COMMISSIONER
GATZUNIS, DPS

COMMENTS

RECOMMENDS ADOPTION
OF THE DRAFT

7TH EDITION 1 & 2

BBRS Draft 5311.5.3.2

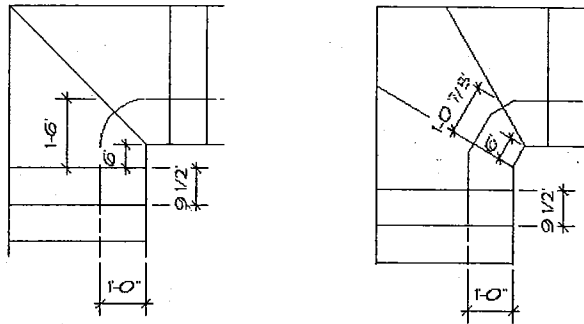
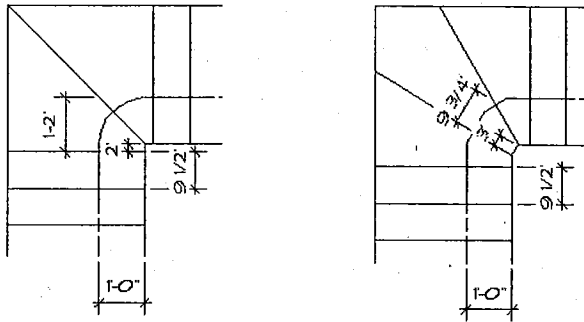
5311.5.3.2 Tread depth. ...Winder treads shall have a minimum tread depth equal to the tread depth of the straight run portion of the stairs measured as above at a point 12 inches (305 mm) from the side where the treads are narrower. Winder treads shall have a minimum tread depth of 6 inches (152 mm) at any point. ...

It is the intent of the code that the rise/run through the winders be as close as possible to that of the straight run portion of the stair. As the code is currently this is not the case as can be seen in the provided diagram. The proposed revision is aimed at getting closer to the intent of maintaining a uniform rise/run throughout the stair as can be seen in the provided diagram.

5311.5.3.2 Tread depth. ...Winder treads shall have a minimum tread depth equal to the tread depth of the straight run portion of the stairs measured as above at a point 12 inches (305 mm) from the side where the treads are narrower. Winder treads shall have a minimum tread of 3 inches (72 mm) at any point.
